ADDITIONAL SUBMISSIONS FOR 2016SYE045
41-49 Willarong Road, Caringbah

12 July 2016

DA16/0223: Caringbah Homemaker Centre – Response to Council

**PARTIAL GROUND FLOOR
PLAN (ARCADE - OPTION 1)**

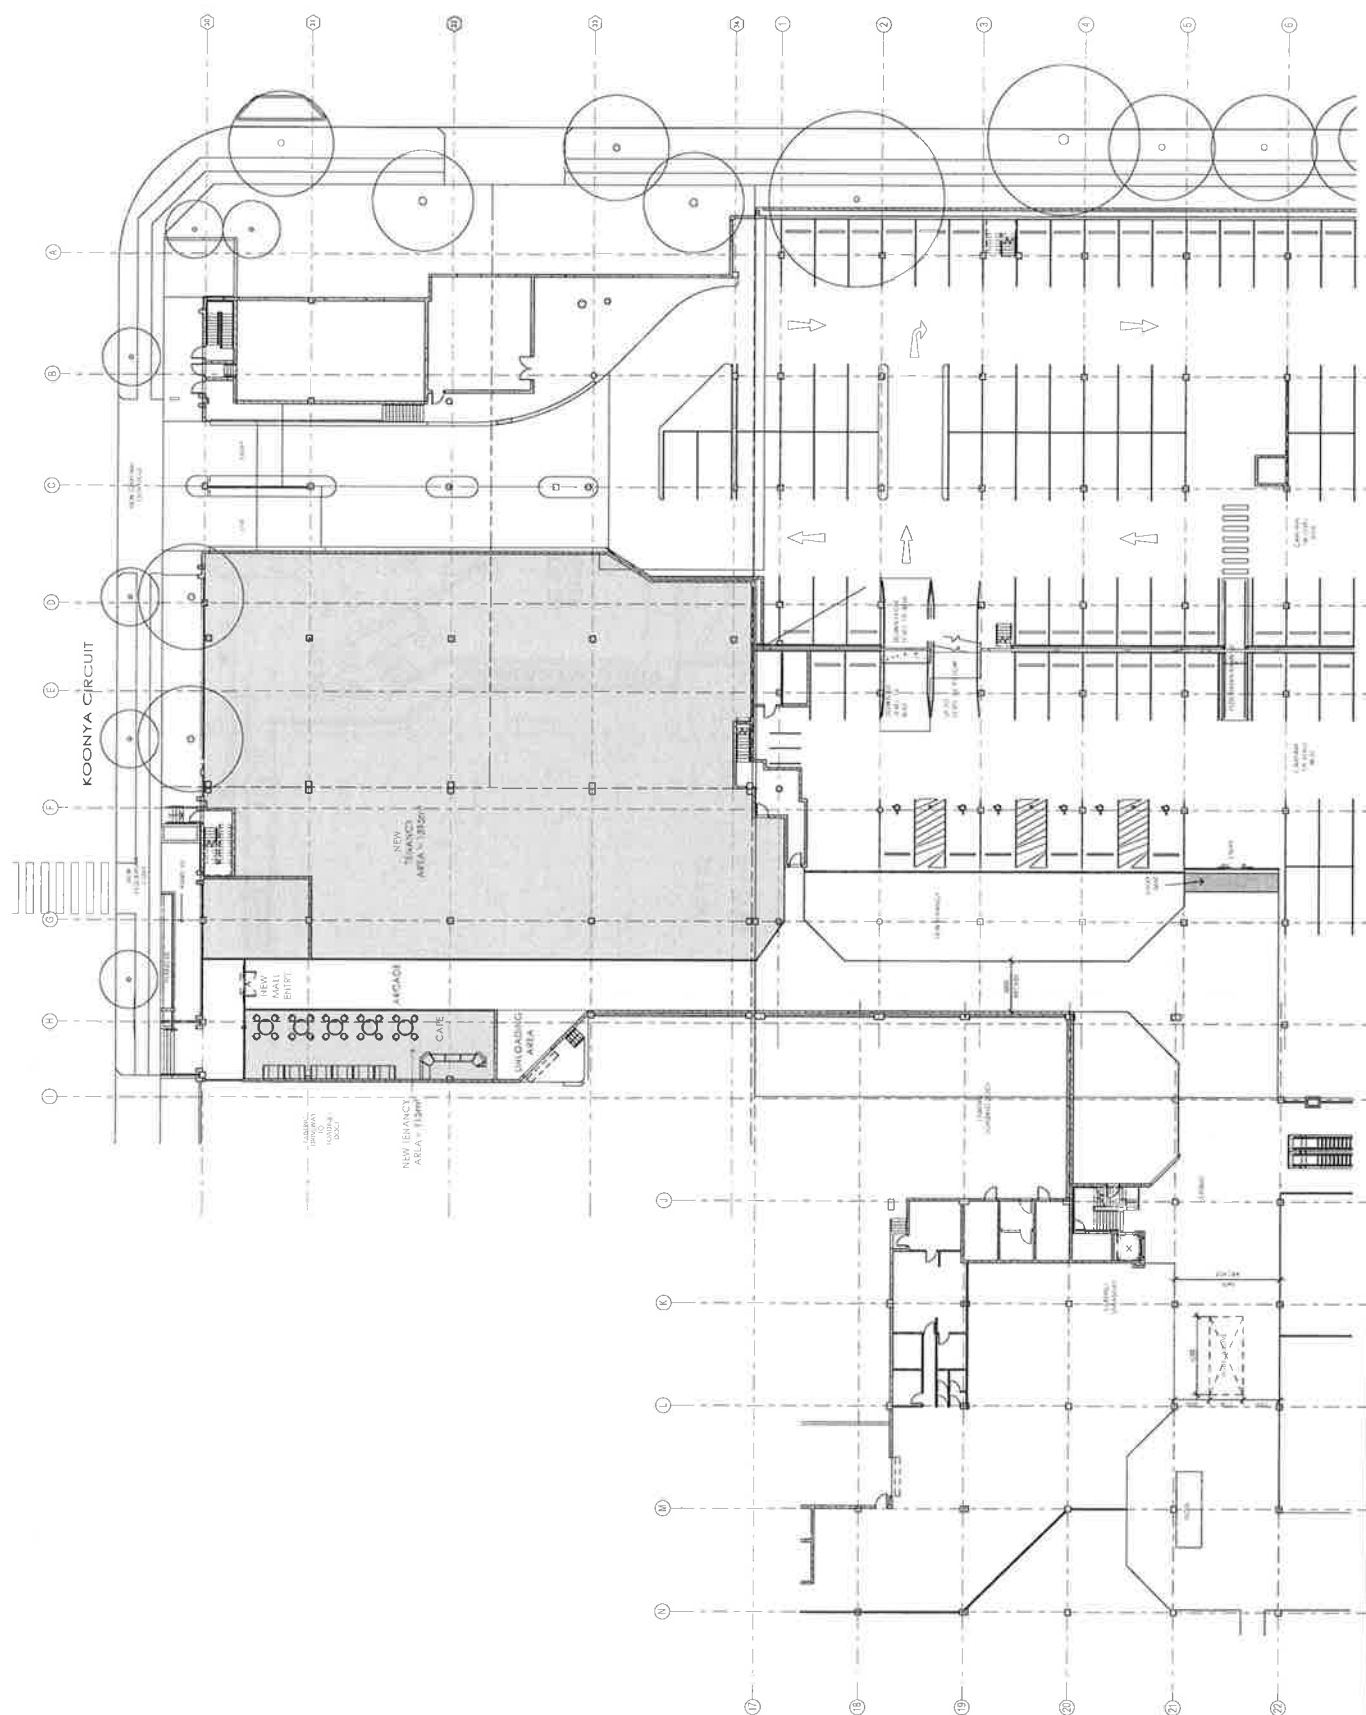
As recommended by the ARAP, we have amended the proposed Ground floor plan and re-aligned the arcade to improve way-finding for pedestrian access into the Centre and to the central vertical access (escalators/lift) to other levels.

This re-alignment also provides activated shopfront each side of the arcade, immediately adjacent to the Koonya Circuit main entry. Flood mitigation from Koonya Circuit is also maintained, as previously proposed, ie: 500mm above the 1:100 flood level. (refer also SK416 showing amended Ground floor plan).

PROPOSED ROOF PLAN -
CARPARK SHADING

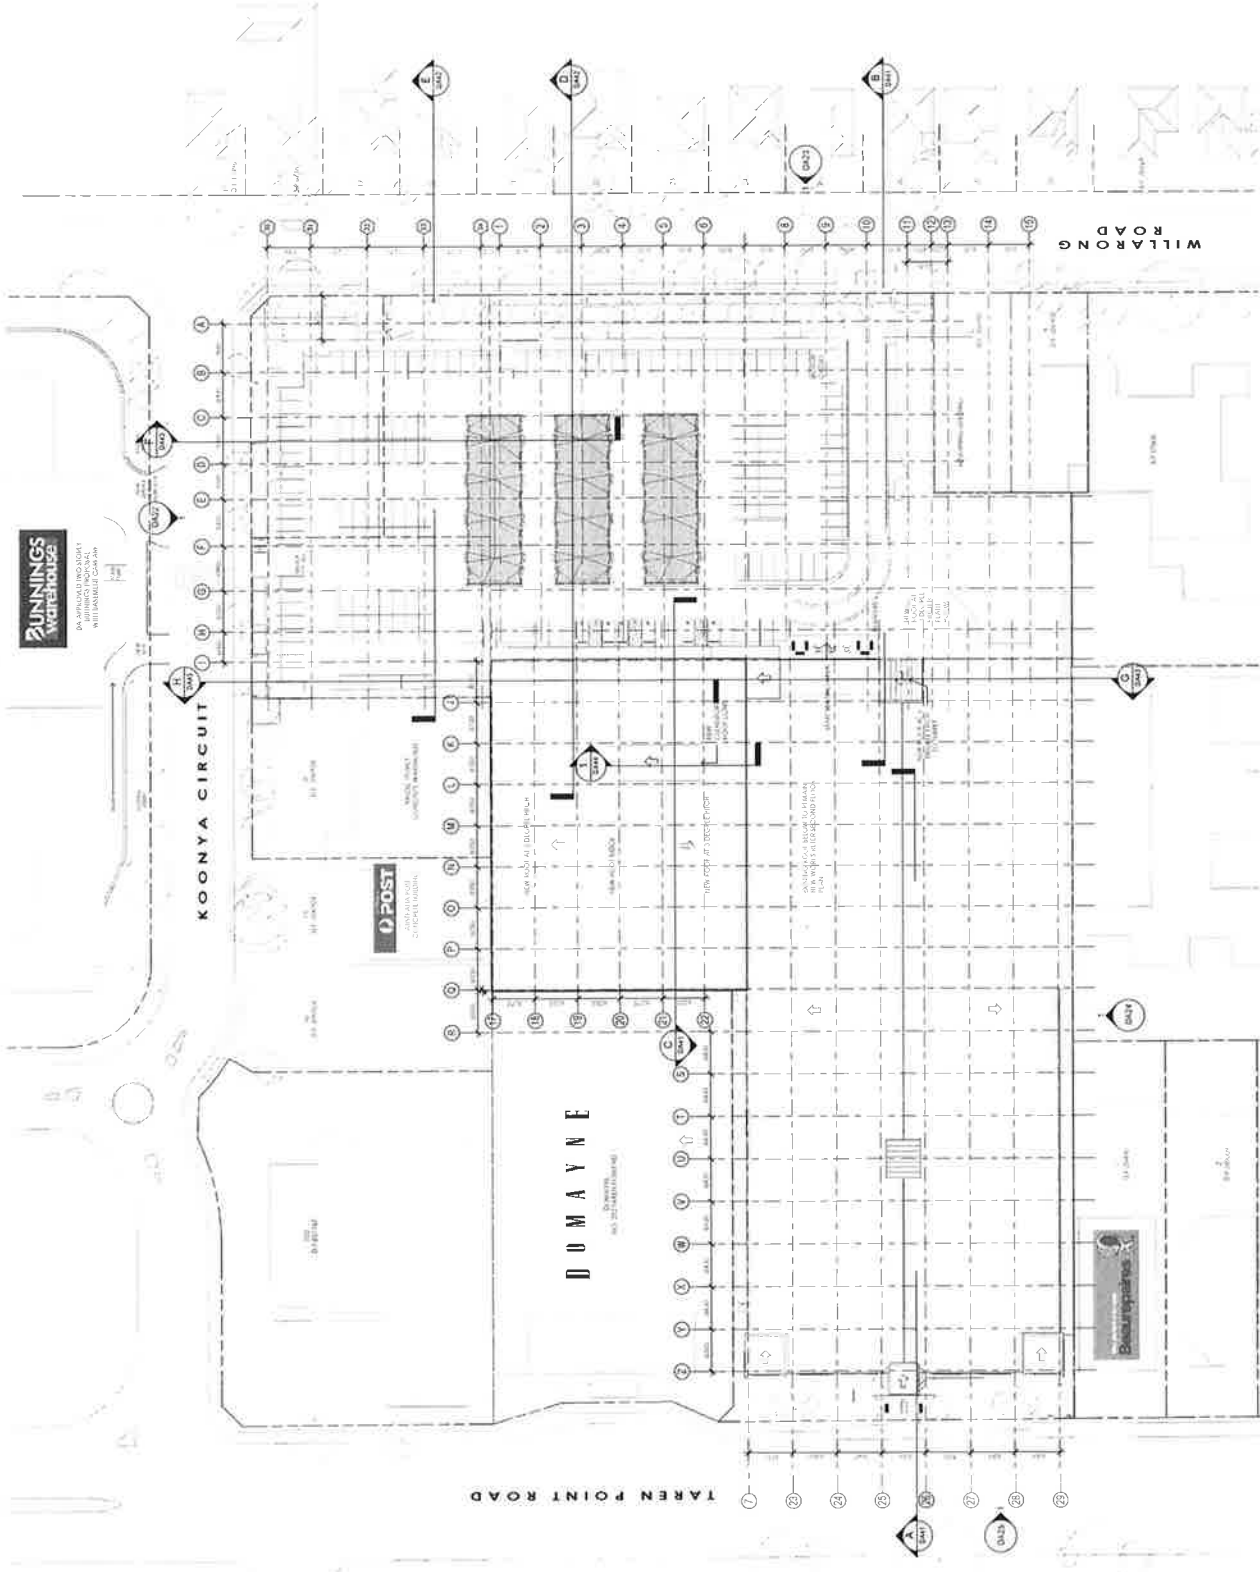
The proposed seating, planter boxes and pergola over the pedestrian walkway on the top level of the car park provide little benefit on their own. As noted by ARAP, light-weight shade structures should be included to provide summer shade and reduce glare.

The rooftop has been updated including the removal of the pergola and the like.

Light-weight shade structures have been introduced to selected car-parking spaces in lieu of pedestrian walkway/pergola element previously proposed on second floor car-park level.

PROPOSED NORTH ELEVATION
KOONYA CIRCUIT 1:500

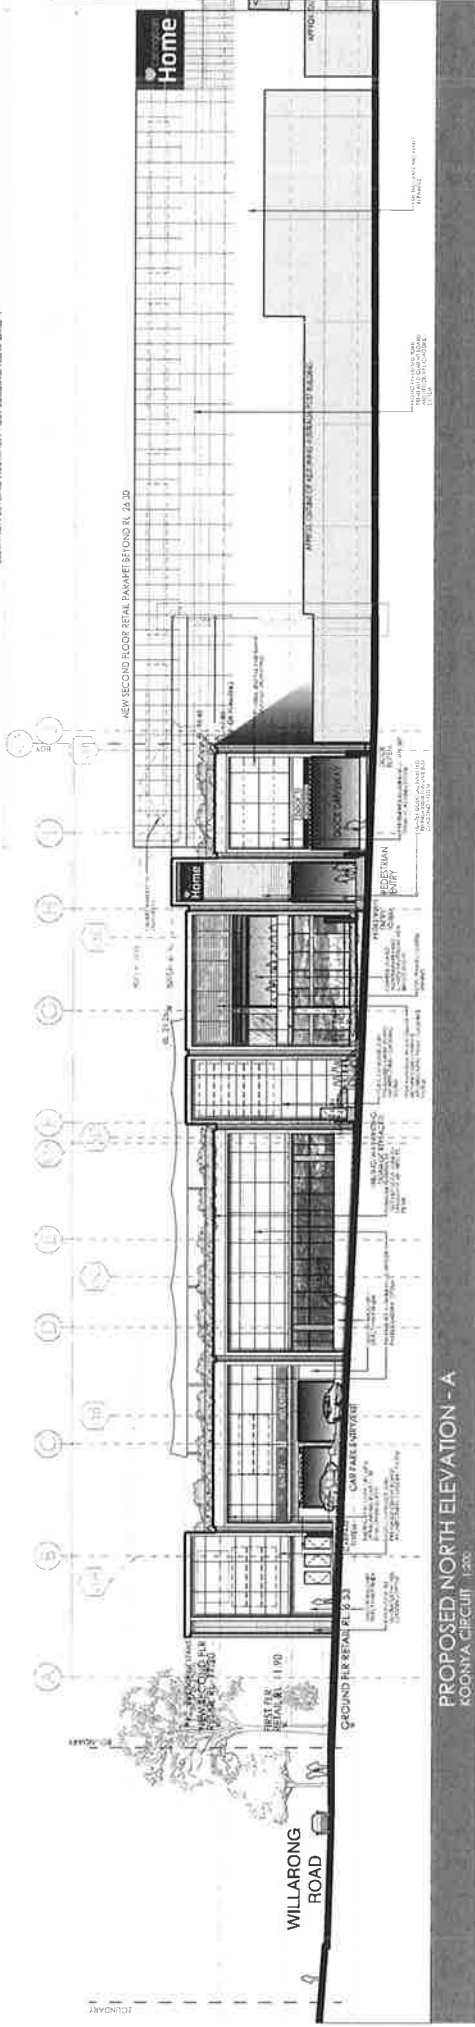
We note that Council have raised concern with the proposed building height of the proposal, and in particular the roof tenancy which exceeds the LEP height standard of 16m.

The current height non-compliance varies from 3,250mm to 4,435mm as indicated on the North Elevation. This height was determined by providing a clear min. internal (springing) height of 6.5m to the underside of steel structure. This was to satisfy the requirements of a prospective Large Format Retail (LFR) tenant seeking to locate at the Caringbah Homemaker Centre, who required a larger floor to ceiling height.

Notwithstanding, as discussed at our recent meeting, the applicant has agreed to reduce the height of the proposed second floor roof tenancy in response to Council's concerns. The absolute 'minimum' height below the lowest point of any structural element for a LFR tenant is 4.5m (which allows for a nominal 4.0m ceiling height plus 500mm above ceiling for building services). Therefore, the extent of non-compliance measured along the north elevation would reduce to approx. 1,250mm and 2,435mm respectively.

Notwithstanding this, amended development plans are attached. As requested, this building element is now clearly shown on all elevations, including perspectives so that the visual impact from Koonya Circuit can be appropriately assessed. Revised plans are also clearly annotated with height in RL and

WILLARONG ROAD TYPICAL SECTION

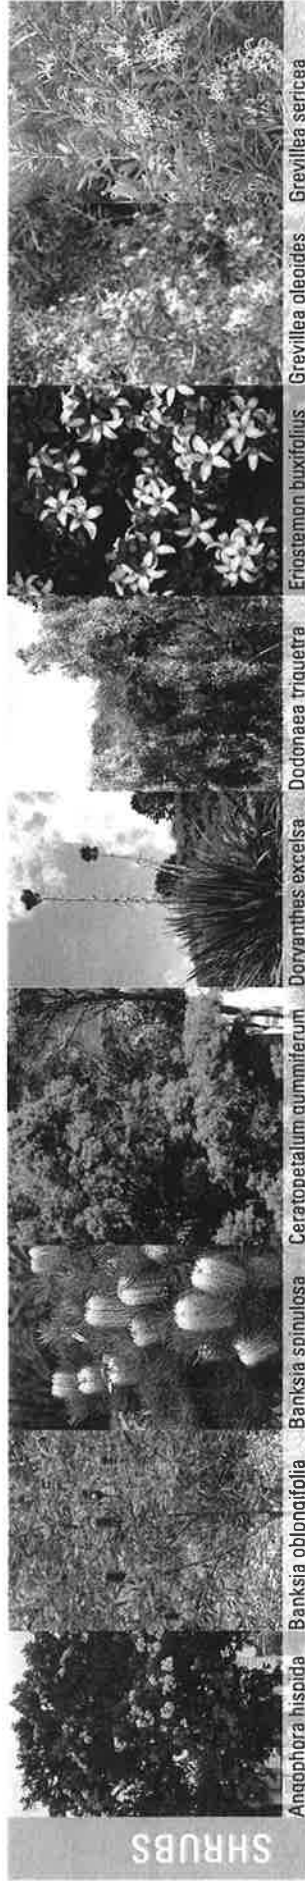
The slab over the basement car park adjacent to Willarong Rd should be sloped to achieve a minimum of 1200mm soil depth where it meets deep soil. This will provide a better transition for the proposed planting than the flat slab currently shown.

The sections have been updated to meet with the requested 1200mm deep soil at the edge of the basement.
